**OFFICIAL COORDINATION REQUEST FOR  
NON-ROUTINE OPERATIONS AND MAINTENANCE**

**COORDINATION TITLE-** 16 IHR 008 Unit 5 blade welding to reduce oil discharge

**COORDINATION DATE-** September 23, 2016, October 21, 2016 - Revised

**PROJECT-** Ice Harbor

CONCEPT SKETCH

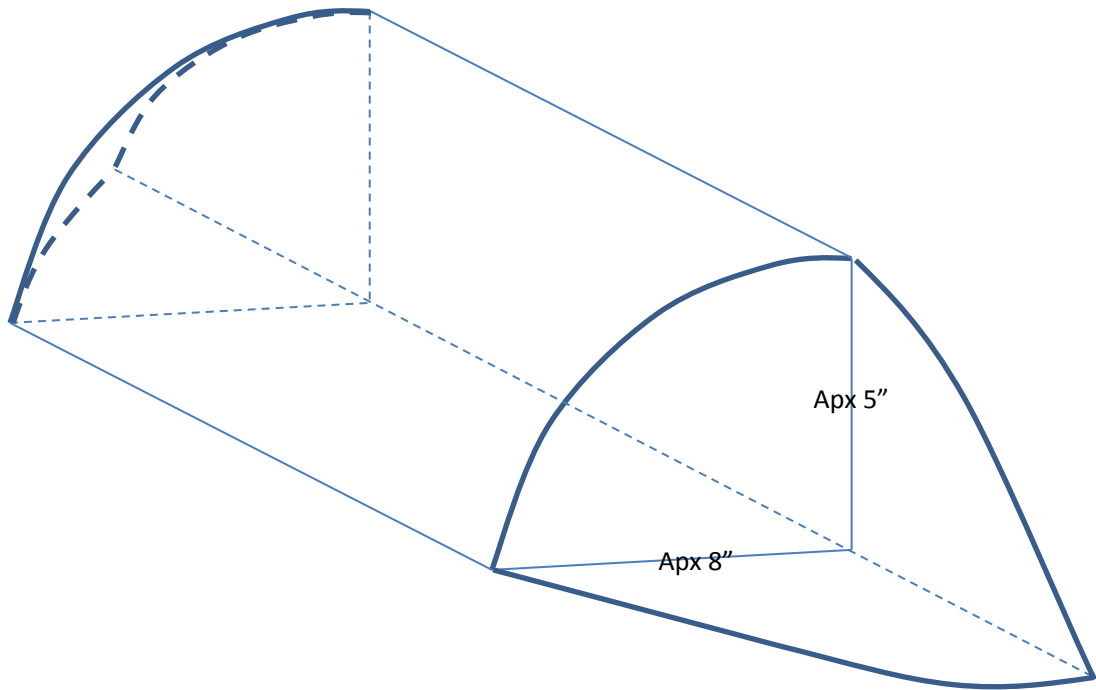
We are requesting some additional information and more discussion on this coordination. Since the MOC indicates the welded blocks will protrude from the runner into the flow potentially impacting juvenile and adult salmonids, and it will likely be a relatively long time until this runner is replaced, we will need to make sure we are taking the appropriate steps to insure we are providing adequate protection for fish given these conditions and time constraints. First, we would like to see a detailed drawing of the blocking and welding schematic that is planned with reference to example photos of completed blade welding from LGR unit 1, and/or IHR unit 2. Also, the MOC does not give a very detailed estimate of the pressures that are expected to occur with the proposed blade angle. I understand that we don't have precise information on pressure for this specific unit, but it would be helpful if the Corps could provide a range of expected pressures so we can weigh those impacts against strike, shear, and other hydraulic impacts.

They are still concerned about the style of the blocks. I told him HDC is designing the blocks with more focus on tapering edges and reducing surfaces that may injure fish. He requested that NOAA be kept in the loop on the design as we move forward.

**Blade Blocking Recommendation:** Doweling the trunnion/hub interface would most likely prevent the turbine runner from ever being reverted back to a Kaplan runner without major rehabilitation. Also, this approach has been attempted on a previous project and has proven not feasible, as it is difficult to bore the dowel hole with the precision required. The two block approach with improvement is therefore recommended. The new block will be longer in the direction of flow with a smaller cross section exposed to the flow. All corners would be rounded smoothly with a large radius, and both the leading and trailing edge of the block will be tapered providing for a more streamlined shape to reduce the likelihood of fish impact and to minimize cavitation (see Figure 2).

Jon and I just talked to Trevor Conder. We (mostly Jon) further explained why we are going with the 24 degree angle. Trevor was okay with the angle once we gave him a more detailed explanation of our thoughts on pressure and he suggested adding further explanation to the MOC to clarify for other folks.
